1150 RAVENDALE DR

Mecklenburg County
Health Department

Re: 1150 Ravendale Drive
File: 1384B
Parcel: 037-029-07

APPLICATION FOR IMPROVEMENT PERMIT FOR RESIDENTIAL SITE INDIVIDUAL WATER AND WASTEWATER SYSTEMS PROGRAM

SOIL/SITE EVALUATION
for ON-SITE WASTEWATER SYSTEM

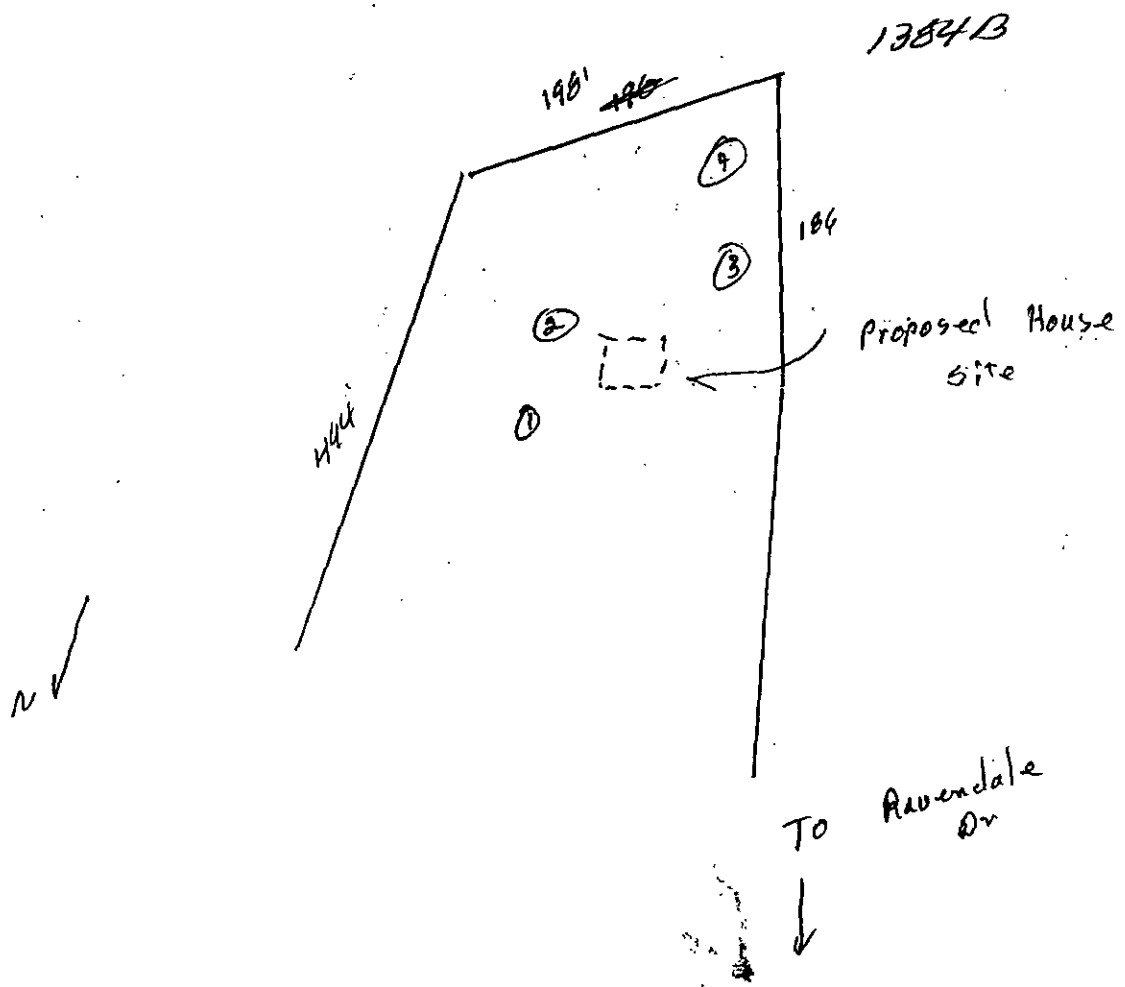
PROFILE #	.1940 LANDSCAPE POSITION/ SLOPE %	HORIZON DEPTH (IN.)	SOIL MORPHOLOGY (.1941) STRUCTURE/ TEXTURE	SOIL MORPHOLOGY (.1941) CONSISTENCE/ MINERALOGY	OTHER PROFILE FACTORS .1942 SOIL WETNESS/ COLOR	.1943 SOIL DEPTH	.1956 SAPRO CLASS	.1941 RESTR HORIZ	PROFILE CLASS & LTAR
1	LS	0-8"	gr/scl	Fr/SExP/SS/SP	>35" TO chroma 2 colors	35"	N/A	None	US
		8-35"	sBK/C	Fi/ExP/S/P					
2	LS	0-8"	gr/scl	Fr/SExP/SS/SP	>40" TO chroma 2 colors	40"	N/A	None	US
		8-40"	sBK/C	Fi-VFi/ExP/S/P					
3	LS	0-4"	gr/cl	Fr/SExP/SS/SP	>16" TO chroma 2 colors	16"	N/A	None	US
		4-16"	sBK/c	Fi-VFi/ExP/S/P					
4	LS	0-6"	gr/cl	Fr/SExP/SS/SP	>16" TO chroma 2 colors	16"	N/A	None	US
		6-16"	sBK/c	Fi-VFi/ExP/S/P

DESCRIPTION	INITIAL SYSTEM	REPAIR SYSTEM
Available Space (.1945)	US	US
System Type(s)

OTHER FACTORS (.1946):
SITE CLASSIFICATION (.1948): Ravendale
EVALUATED BY: William R. Marlin 6-13-96
OTHER(S) PRESENT:

SOIL/SITE EVALUATION
for ON-SITE WASTEWATER SYSTEM

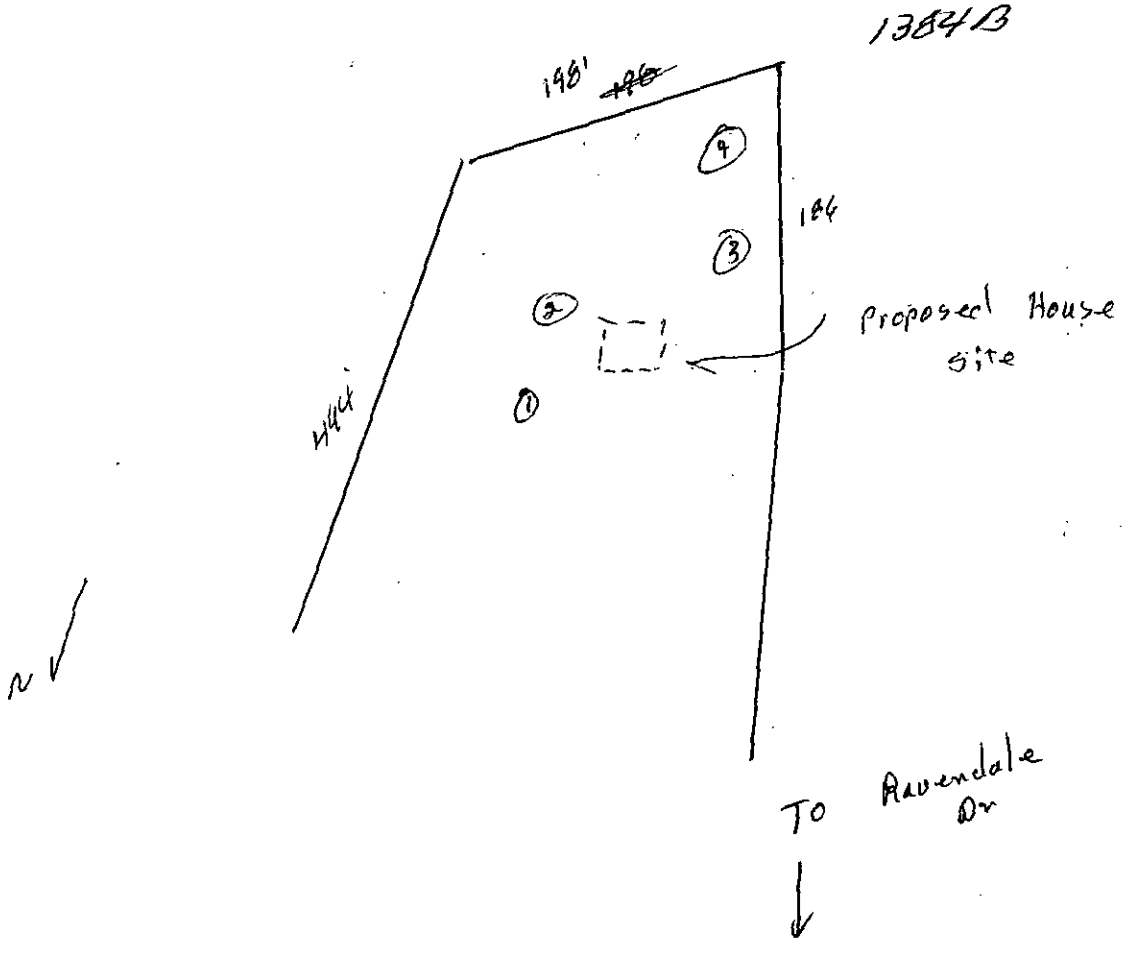
PROFILE #	1940 LANDSCAPE POSITION/ SLOPE %	HORIZON DEPTH (IN.)	SOIL MORPHOLOGY (.1941) 1941 STRUCTURE/ TEXTURE	1941 CONSISTENCE/ MINERALOGY	OTHER PROFILE FACTORS 1942 SOIL WETNESS/ COLOR	1943 SOIL DEPTH	1956 SAPRO CLASS	1944 RESTR HORIZ	PROFILE CLASS & LTAR
1	LS	0-8"	gr/scl	Fr/SEXP/SS/SP	>35" TO Chroma 2 colors	35"	N/A	None	US
		8-35"	SBK/C	Fi/EXP/S/P					
2	LS	0-8"	gr/scl	Fr/SEXP/SS/SP	>40" TO Chroma 2 colors	40"	N/A	None	US
		8-40"	SBK/C	Fi-VF/EXP/S/P					
3	LS	0-4"	gr/l	Fr/SEXP/SS/SP	>16" TO Chroma 2 colors	16"	N/A	None	US
		4-16"	SBK/C	Fi-VFi/EXP/S/P					
4	LS	0-6"	gr/l	Fr/SEXP/SS/SP	>16" TO Chroma 2 colors	16"	N/A	None	US
		6-16"	SBK/C	Fi-VFi/EXP/S/P

DESCRIPTION	INITIAL SYSTEM	REPAIR SYSTEM
Available Space (.1945)	US	US
System Type(s)		
Site LTAR

OTHER FACTORS (.1946):
SITE CLASSIFICATION (.1948): Recommended
EVALUATED BY: William R. Moulin 6-13-96
OTHER(S) PRESENT:

Not sure if WW Repair required
